RE: DA2022/1715 – 60 Hudson Pde Clareville NSW 2107

Letter of Objection on behalf of Mr Richard Utz 58 Hudson Parade

8.5 m height restriction/ Roof Form

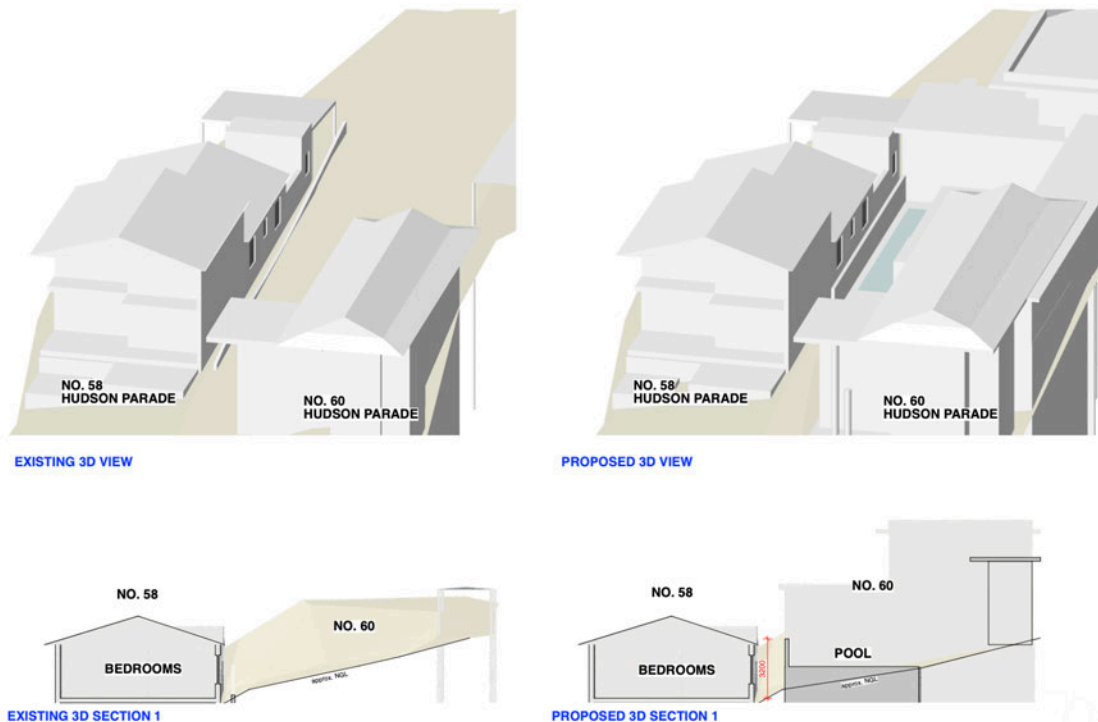
The removal and raising of the existing roof of an iconic and intact home designed by one of Sydney's leading architects is considered to be unnecessary and a breach of moral rights in regard to and respect for the original design by Bruce Rickard. This intervention is contradictory to a sympathetic approach to retaining the existing home and with neighbouring dwellings. The change in height will increase the bulk and scale of the existing building and result in demolition of much of the original building fabric.

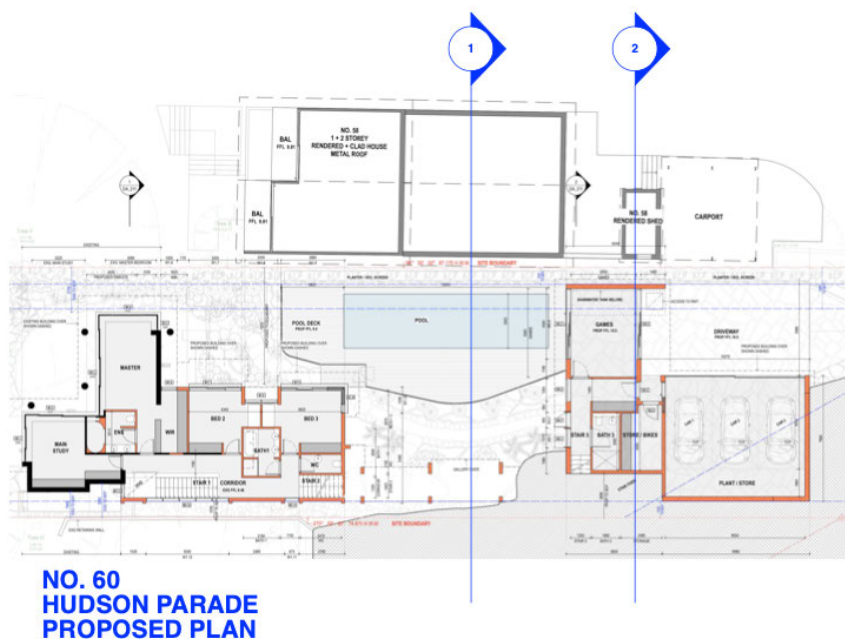
The existing bedroom windows located on the southern side of No. 58 will be greatly affected by the proposed location of the pool, pool deck and planter which are located on the boundary and are way outside Council's requirements. The FFL of the bedrooms is 7.35 and the pool deck is at RL 9.0. The pool fence requirement will be 1m higher than this.

Currently these bedrooms look into the garden of No. 60 and get limited access to sunlight due to the topography and aspect however the proposed planter (which has not been fully described in the drawings in terms of height) and proposed 'screen' planting will block any access to daylight and view and ventilation to the existing bedrooms.

Note position of bedroom windows in relation to planter and pool deck in 3-D images below.

Sections above taken through pool deck, from survey of No. 58 and Architectural drawings for application as per plan below

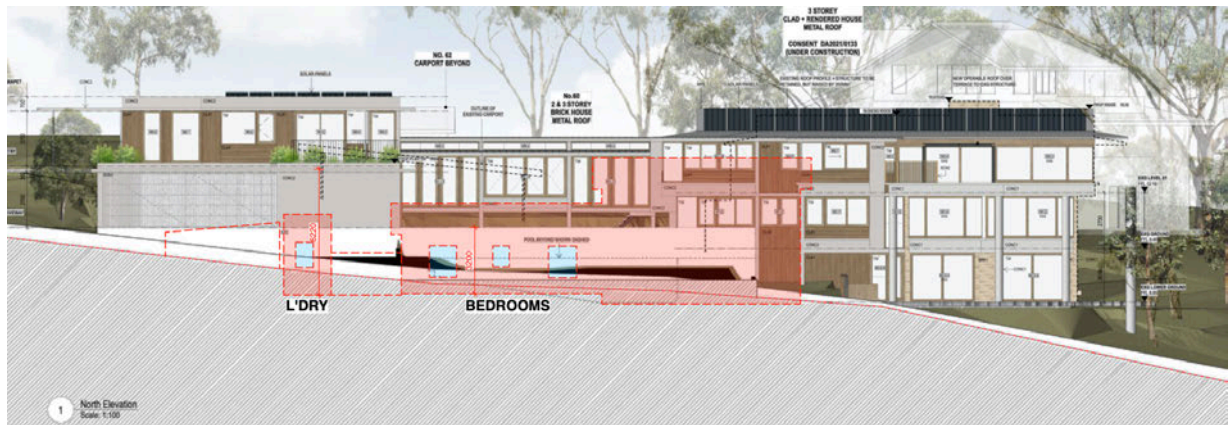
The pool deck is at a height of R.L 9.0 which is 2m higher than the existing courtyard level of R.L7.0 of no. 58 and the proposed retaining wall and planter is on the boundary. The pool fence will therefore be at a height of 3m above Natural Ground Level at a distance of 1m from the boundary. This will have a huge impact on the visual and acoustic amenity of the existing bedrooms as well as creating a huge visual obstruction on the boundary, with decreasing access to daylight and outlook from the only windows available to these rooms and the entry courtyard to the property. The entry courtyard of No. 58, will be overlooked by the proposed games room and adjacent green roof and will have a 3m high planter and pool fence 1m from the boundary.

See diagram of proposed in relation to No. 58 (bedroom windows shown in blue) look into blank wall.

D1.9 Side and Rear Building Line

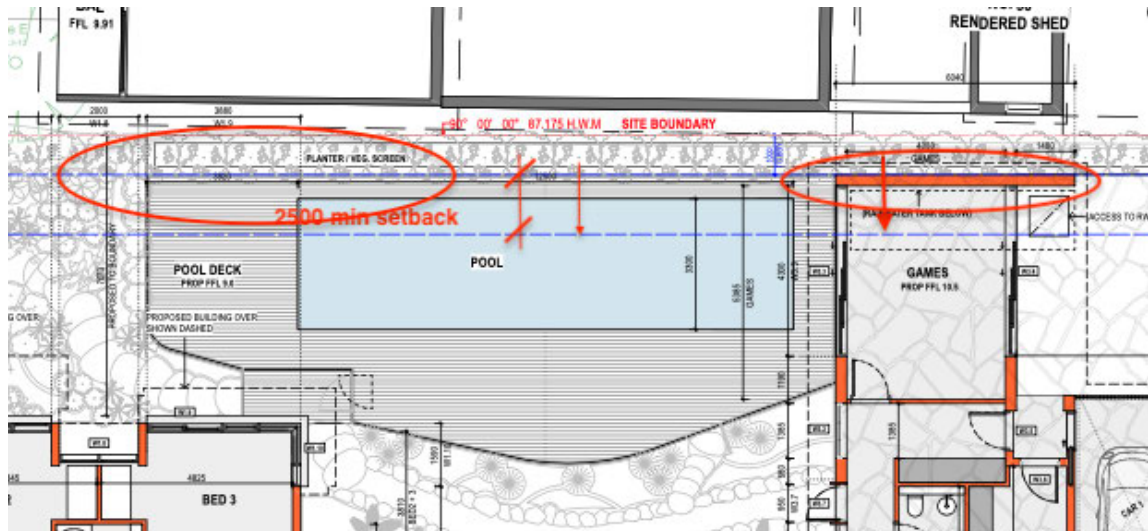
The side setback of 1m on the northern boundary of the subject site is not in accordance with this clause. The setback on the southern boundary is 1m and should therefore be increased to 2.5m minimum on the northern boundary. The pool deck should be within 2.5m from this boundary. The SEE is misleading regarding this set-back requirement. See diagram below:

D1.11 Building Envelope

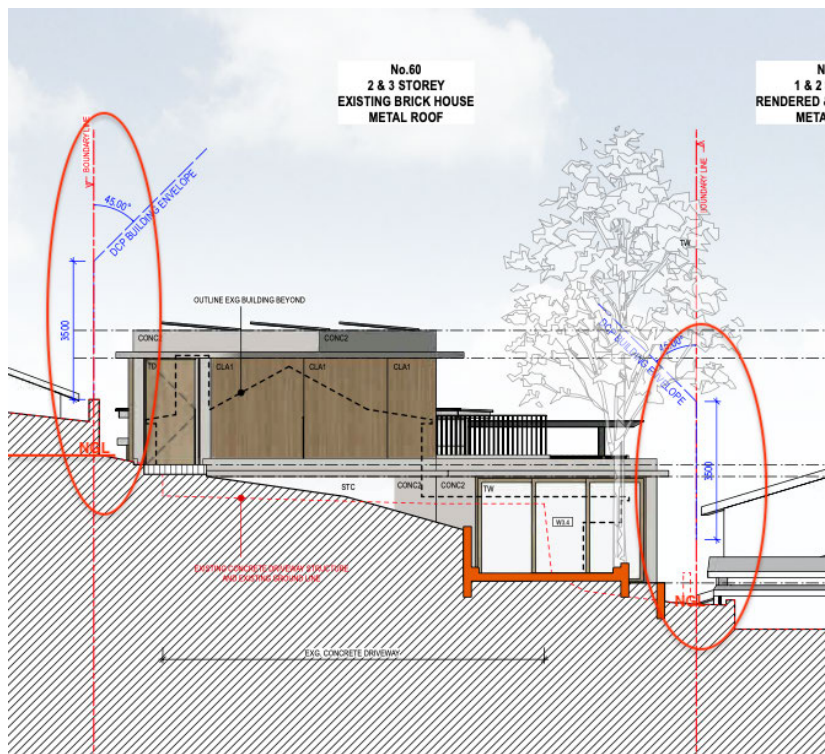
We have modeled the dwelling at No. 58 in relation to the proposed application to illustrate the adverse impacts of the proposed pool, pool deck and planter. The Building Height Envelope shown on the application Dwg East Elevation 1 are taken well above NGL on both boundaries and are misleading. The envelope is measured from NGL not on top of existing fences. The outcomes of this clause have not been met and a section through the pool and pool deck in relation to No. 58 clearly illustrates this.
